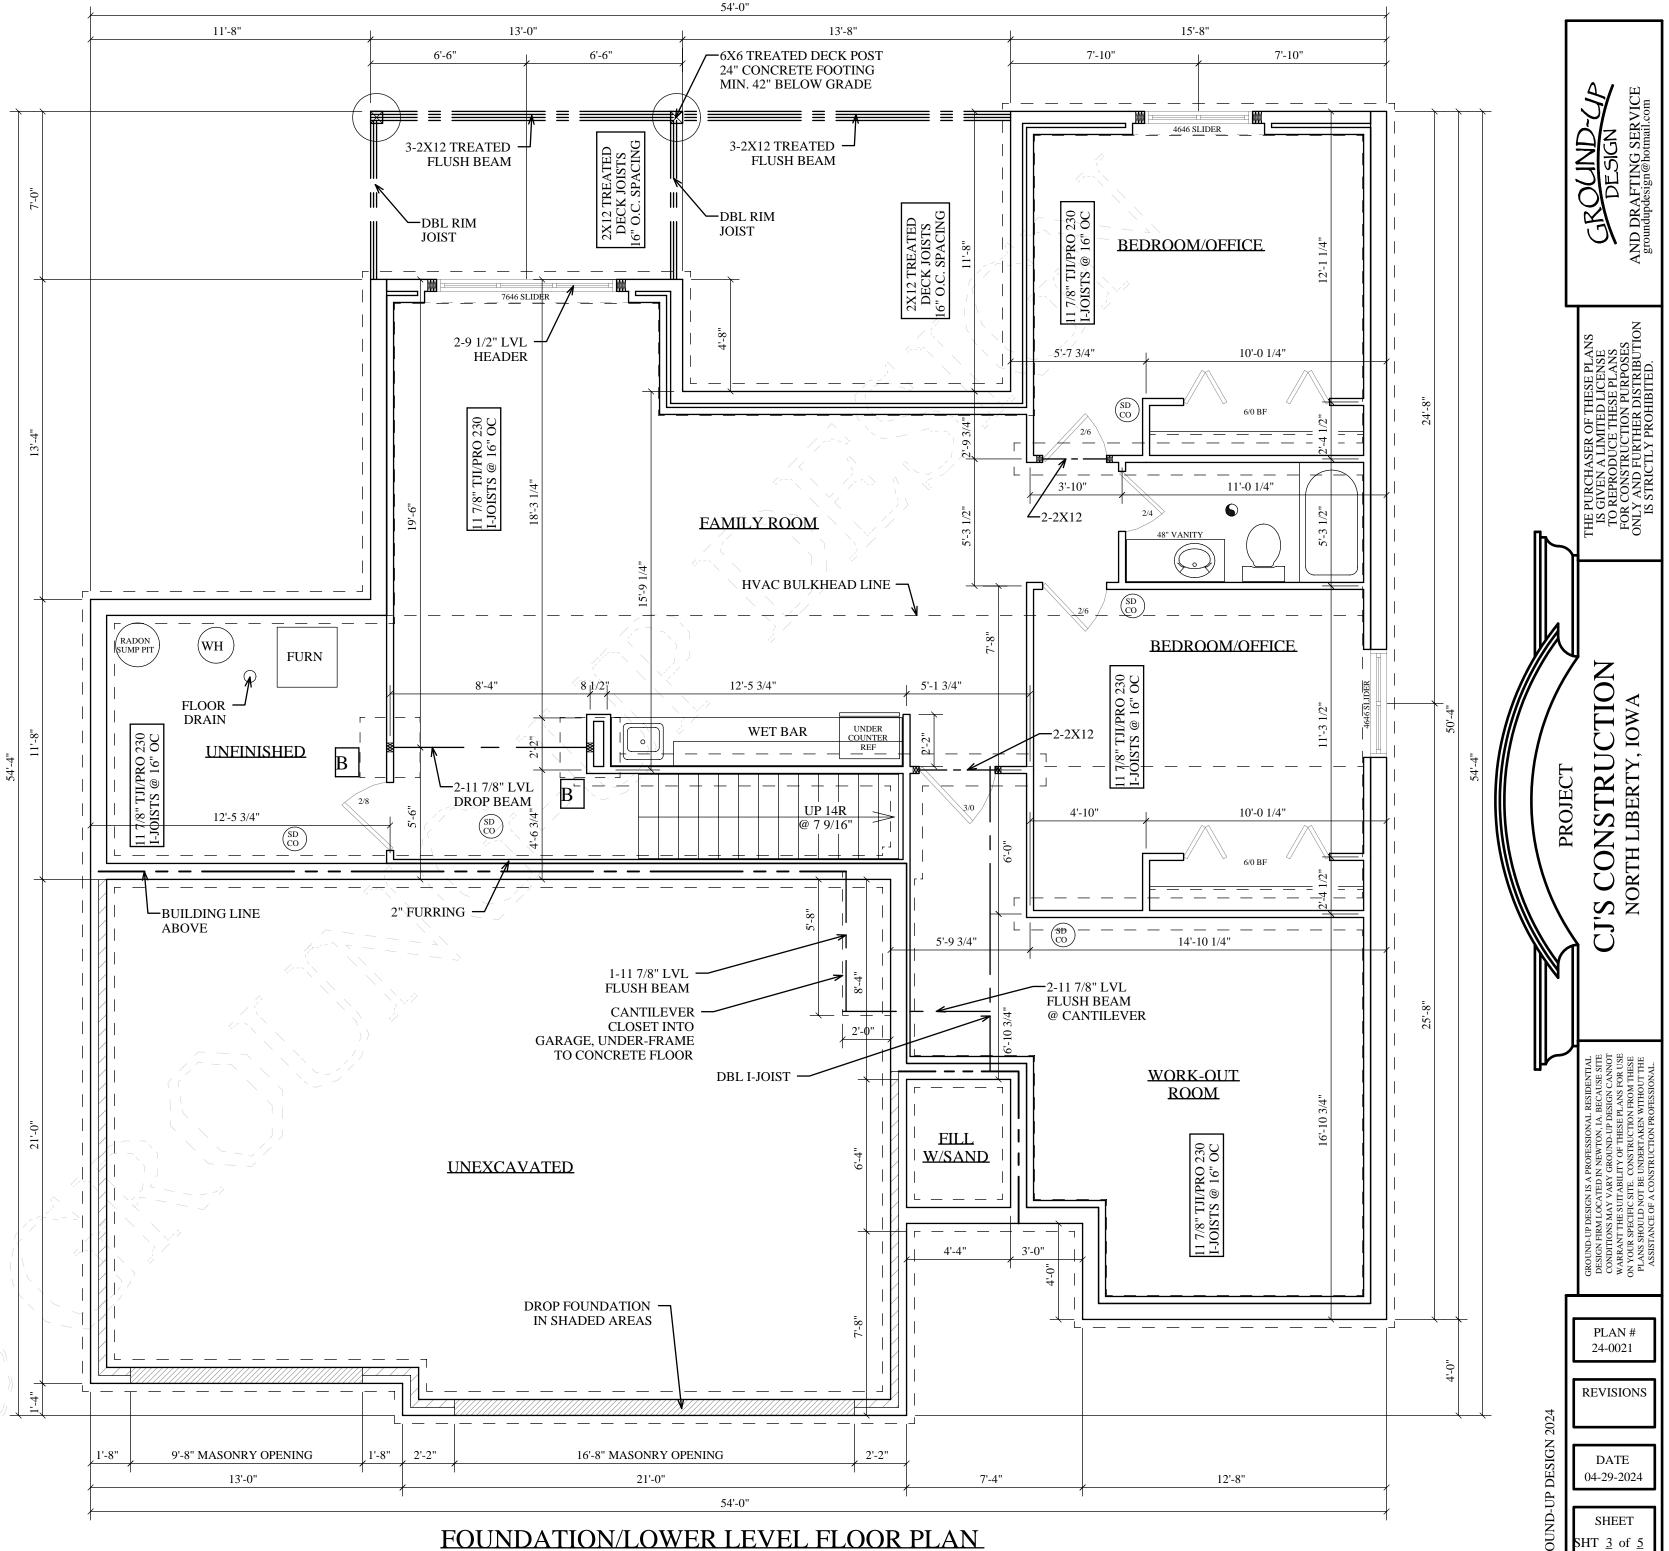
9. Egress windows need to be identified

10. Deck footings are required to be properly sized.
